**Subject: Formal Public Input – Metro Toronto Condominium Corporation 1067 and PWI Company**  
**Re: Item SC7.2 – 3850 and 3900 Sheppard Avenue East and 2350-2362 Kennedy Road – Official Plan Amendment – Final Report**

**RE: Peer Review Summary of Transportation Studies for Agincourt Mall Redevelopment**

LEA Consulting Ltd. (LEA) was retained by MTCC No. 1067 to provide a peer review of the transportation studies submitted (City File No. 17 181232 ESC 40 OZ) for the Agincourt Mall Redevelopment, located on the northwest corner of Sheppard Ave E and Kennedy Rd. The purpose of this peer review is to determine any implication of the Agincourt Mall Redevelopment to the existing development and intensification potential for 2347 Kennedy Rd & 4002 Sheppard Ave E, which is a property owned and operated by MTCC No. 1067. **Figure 1** illustrates the location of the Agincourt Mall redevelopment and 2347 Kennedy Rd & 4002 Sheppard Ave E.

**Figure 4: Soft Site Locations in the October 2017 Segment Study**

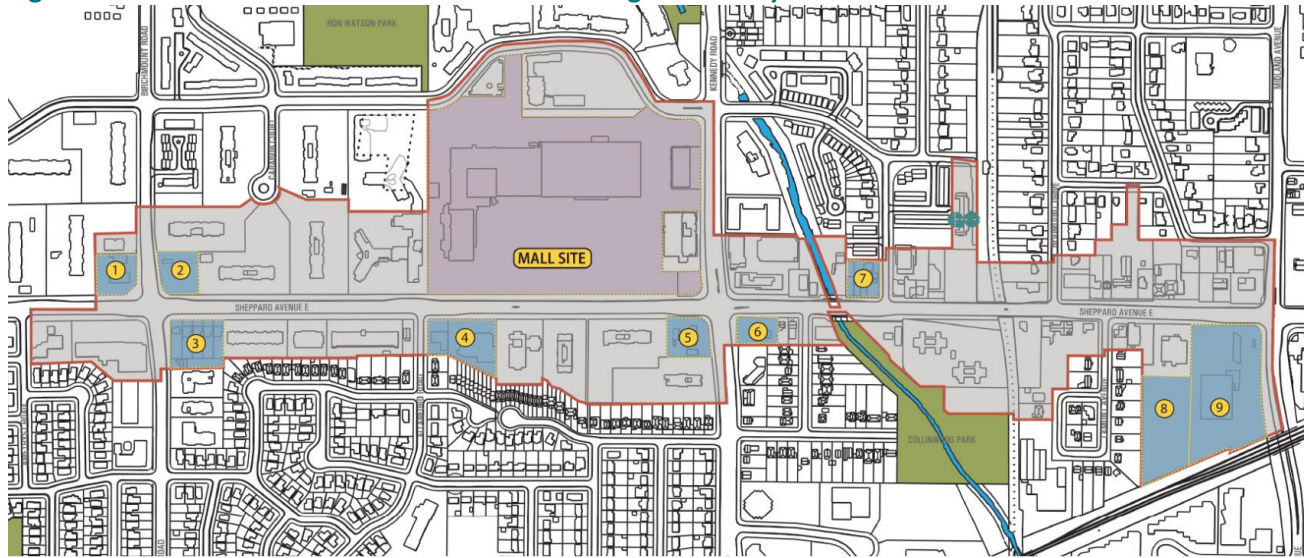
A total of eight soft sites were identified by the planning consultant for the Agincourt Mall Redevelopment and 8 were included in the traffic analyses. A ninth development was not included as a formal development application has been submitted and was included in the June 2017 Study. Majority of the identified soft sites consist of potential residential condominium units and retail space. It is noted that the potential intensification of 2347 Kennedy Rd & 4002 Sheppard Ave E was not considered as a soft site in this October 2017 study. However, 2347 Kennedy Rd & 4002 Sheppard Ave E was included as a soft site, without an updated analysis in the February 2019 Update. **Figure 4** illustrates the study area in the October 2017 Segment Study.

As mentioned in Section 2.3, the potential intensification of 2347 Kennedy Rd & 4002 Sheppard Ave E was not considered as a soft site in the October 2017 Segment Study. With the inclusion of 2347 Kennedy Rd & 4002 Sheppard Ave E as part of the soft site transportation analysis the performance of the intersection has not been appropriately considered at this time.

**Figure 5: Soft Site Locations in the February 2019 Update**

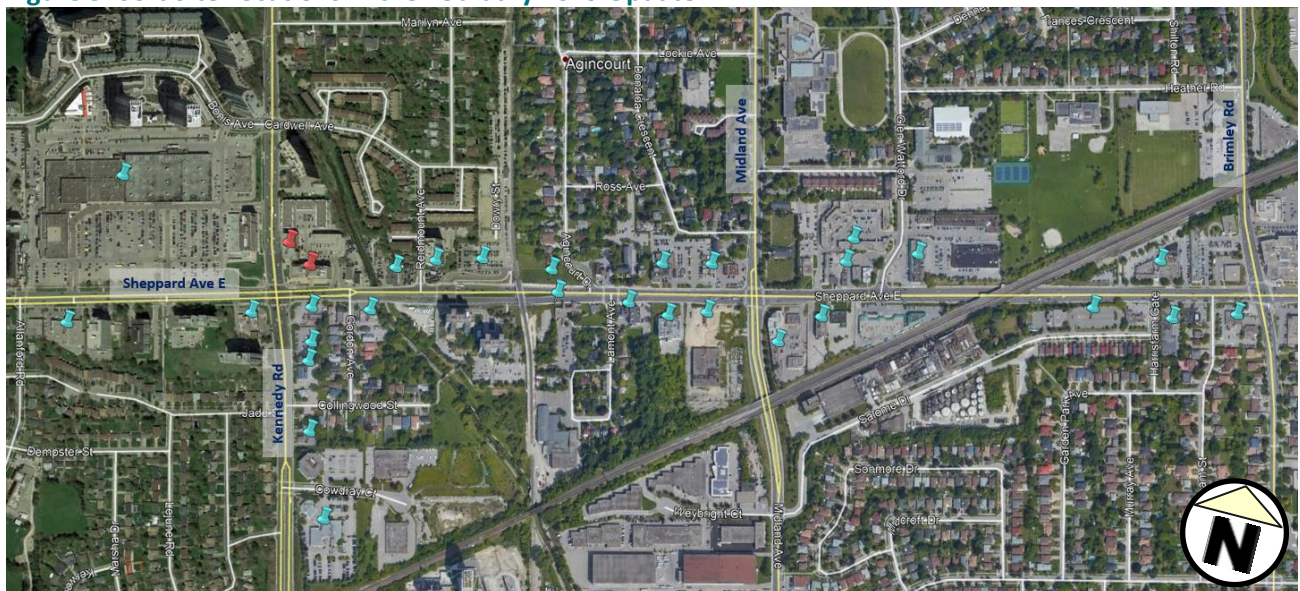
1. As part of the Agincourt Mall Planning Framework Review, 30 existing and potential development sites were identified and assessed by four Distinct Development Scenarios, which look at mid- or high-rise development of the soft-sites with an FSI from 3.0 to 4.0. It is noted that 2347 Kennedy Rd and 4002 Sheppard Ave were identified as two of the 30 soft sites. **Figure 5** illustrates the location of the identified soft sites, with the red pins identifying the location of 2347 Kennedy Rd and 4002 Sheppard Ave.

2. Three of the eight soft sites identified in the October 2017 Segment Study (3600 Sheppard Ave E & 2340 Birchmount Rd, 3750 Sheppard Ave E & 20 Carabob Cres, and 3717-3725 Sheppard Ave E & 2255 Birchmount Rd) were not included within the soft sites. It was noted a reason was not provided within the February 2019 Update as to why the aforementioned soft sites were excluded.

3. The updated soft site analysis, which includes a total of 30 soft sites with development of up to 4.0 FSI for each block has not been technically assessed in the February 2019 Update conducted by BA Group.
